Fashion & Styles

Pakistan ACCORD for Health and Safety in the Garment and Textile Industry

Electrical Safety Inspection Report

Pakistan Accord Initial Safety Inspection Report

Figure 2.1 - 250A circuit breaker on 25sq.mm cable observed in main LT panel at ground floor of building 1

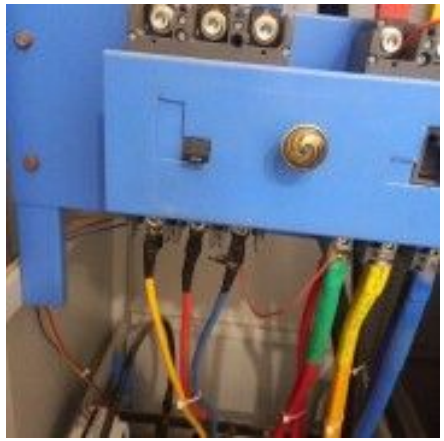
It was observed that multiple circuit breakers had ratings that were not appropriate for the connected cable sizes. Issues observed are as follows:

i. 250A circuit breaker on 25sq.mm cable observed in main LT panel at ground floor of building 1.
ii. 100A circuit breaker on 4sq.mm cable observed in main distribution board at first floor of building 1.

Specifically, some circuit breakers had higher ratings than the cables could safely handle, which poses a significant risk of overheating and potential fire hazards. Conversely, other circuit breakers had lower ratings than necessary, resulting in frequent and unnecessary tripping. To ensure both safety and operational efficiency, corrective action is required to align the circuit breaker ratings with the cable capacities. This adjustment will mitigate the risks associated with overheating and improve the reliability of the electrical system. F-202603-063920

Timeline	Remediation Plan
Medium Term CAP-0074809	Evaluate the breaker ratings and cable sizes for all circuits in the facility according to Section 433.1.1 and Appendix 4 of BS 7671 18th Edition + A2 (2022). Ensure that the breaker rating does not exceed the cable's current-carrying capacity. If the breaker has adjustable settings, they must be configured to allow current within the cable's ampacity after applying derating factors.

Figure 2.3 - Hotspot observed in main distribution board at second floor of building 1

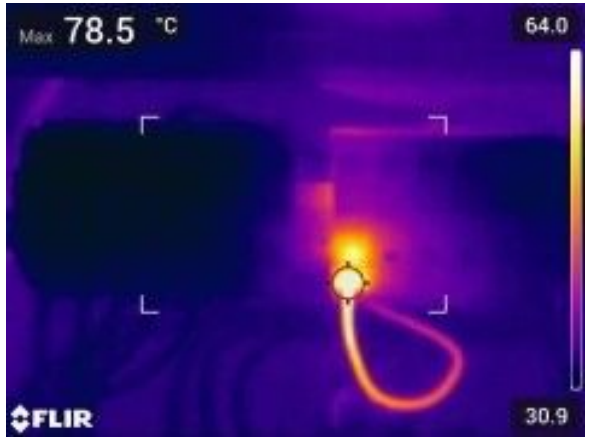
i. Hotspot of 78 °C was observed in main distribution board at second floor of building 1.
ii. Hotspot of 54 °C observed in main distribution board at first floor of building 1.
iii. Hotspot of 53 °C was observed in lighting distribution board at ground floor of building 1.

All temperature-related assessments are based on Table 100.18 of ANSI Standard 2019.
It was also observed that the thermography report for the factory was not available at the time of inspection.

Hot spots in electrical systems pose significant life safety risks due to several factors. Overheated components can ignite surrounding materials, leading to electrical fires. This is particularly dangerous in densely packed panels and distribution boards where flammable materials may be present. Hot spots can degrade insulation on wires and components, increasing the risk of electrical shock to personnel who might come into contact with exposed conductive parts. Overheating can contribute to conditions that might trigger an arc flash, a dangerous high-temperature event that can cause severe injuries or fatalities to personnel working near the affected equipment. F-202603-063924

Timeline	Remediation Plan
Immediate CAP-0074880	Any circuits identified on site with temperatures exceeding 40°C above the ambient temperature, operating above 90°C or exhibiting visual signs of burning must be immediately isolated and taken out of service. These circuits should remain de-energized until a thorough review has been conducted and appropriate remedial actions have been implemented to resolve the underlying issues.
Medium Term CAP-0074881	During the inspection, several circuits were identified where the temperature was exceeding 20°C above ambient temperature, as illustrated in the example images below. It is recommended that the factory conducts comprehensive thermographic surveys of all electrical panels to detect similar issues. Identified hot spots should be thoroughly reviewed to determine their underlying causes. Corrective actions must be taken to address and resolve these issues, ensuring safe and reliable operation of the electrical systems.

Longer Term CAP-0074882	Regular thermographic inspections should be incorporated into the maintenance schedule to proactively manage and mitigate the risks associated with overheating.

Figure 2.30 - No exit signage observed at ground floor of building 1

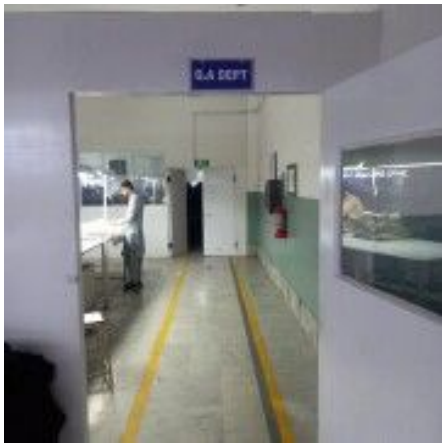
i. Emergeny light and exit signage layout was missing for the factory.
ii. Several areas lack sufficient emergency lighting and exit signage coverage.
iii. External emergency lighting was not provided, preventing people from reaching a place of safety outside the facility during nighttime evacuations.

Adequate and functional emergency lighting throughout the facility is crucial for providing necessary illumination during power failures or other emergencies, ensuring the safe evacuation of workers.F-202603-063923

Timeline	Remediation Plan
Medium Term CAP-0074874	i. Conduct a comprehensive survey to identify areas lacking adequate emergency lighting specified in the Building Code of Pakistan Fire Safety Provisions 2016, ensuring sufficient illumination for safe evacuation.
Medium Term CAP-0074875	ii. Once the means of egress layouts have been finalised, develop a detailed emergency lighting and exit signage layout as per Building Code of Pakistan Fire Safety Provisions 2016 and submit it to Pakistan Accord for review.
Medium Term CAP-0074876	iii. Install emergency luminaires to enable safe evacuation during hours of darkness all the way to a safe place outside the building(s).

Longer Term CAP-0074877	Establish a regular maintenance and testing schedule to check the functionality of emergency lighting systems routinely. This should include periodic tests, inspections, and prompt maintenance actions to address any issues. Maintain detailed records of all inspections, tests, repairs, and maintenance activities. Train facility maintenance staff on the procedures for inspecting and maintaining emergency lighting systems to ensure ongoing reliability and compliance with safety standards.

Figure 2.42 - Taped joints observed in main distribution board of office area at ground floor of building 2

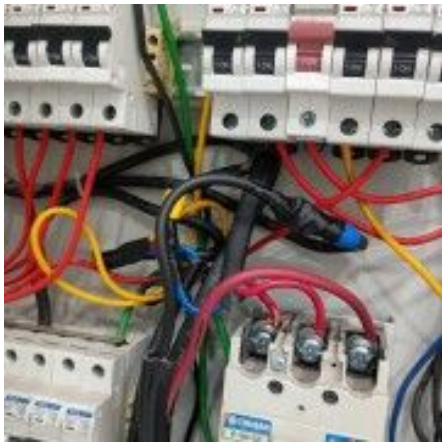
i. Cables terminations within panels and switchgears were made without cable lugs, resulting in breaking strands and loose connections. This presents a significant fire risk due to the potential for electrical arcing and overheating, which can ignite nearby materials and cause a fire. Furthermore, loose connections can cause voltage drops and equipment malfunctions, posing a life safety hazard. This issue was observed in both building 1 & 2.
ii. PVC tape joints were found in several locations - including within distribution boards - where cables were either damaged or two cables were being joined together. This method of jointing is unreliable and can deteriorate over time, increasing the risk of electrical shorts and fires. The adhesive on PVC tape can degrade, leading to exposed conductors that can spark and ignite surrounding materials, presenting both fire and life safety risks. This issue was observed in both building 1 & 2.

iii. Machine power wires were inserted directly into power receptacles without a power plug. This practice is highly dangerous as it can lead to loose connections, electrical shocks, and short circuits. Direct insertion bypasses proper safety mechanisms, significantly increasing the risk of fire and electrical hazards, thereby endangering life safety. This issue was observed in both building 1 & 2.

For any future electrical work, the termination of stranded cables must be done with cable lugs and PVC tape joints shall not be utilised. Proper termination ensures secure and reliable connections, reducing the risk of electrical failures and enhancing overall safety. F-202603-063916

Timeline	Remediation Plan
Medium Term CAP-0074796	i. install cable lugs on all improperly terminated cables within panels and switchgears to secure connections and prevent breaking strands and loose connections in accordance with Regulation 526.1 of BS7671 18th Edition + A2 (2022)
Medium Term CAP-0074797	ii. Replace all PVC tape joints with proper terminal blocks or connectors to ensure secure and stable connections in accordance with Regulation 526.1 of BS7671 18th Edition + A2 (2022). Replace all damaged cabling with new wiring.

Medium Term CAP-0074798	iii. Replace the directly inserted power wires with proper power plugs to ensure safe and secure connections.
Longer Term CAP-0074799	i. Implement a standard operating procedure (SOP) requiring the use of cable lugs for all future cable terminations. Regularly train and audit personnel to ensure compliance with this procedure, thus maintaining safe and reliable electrical connections.
Longer Term CAP-0074800	ii. Establish a policy prohibiting the use of PVC tape for electrical jointing. Regularly inspect and maintain electrical installations to ensure compliance, and provide continuous training for staff on proper jointing techniques.
Longer Term CAP-0074801	iii. Develop and enforce a facility-wide electrical safety protocol that mandates the use of power plugs for all equipment. Conduct regular safety audits and provide training sessions to staff to reinforce the importance of using proper power plugs and adherence to electrical safety standards.
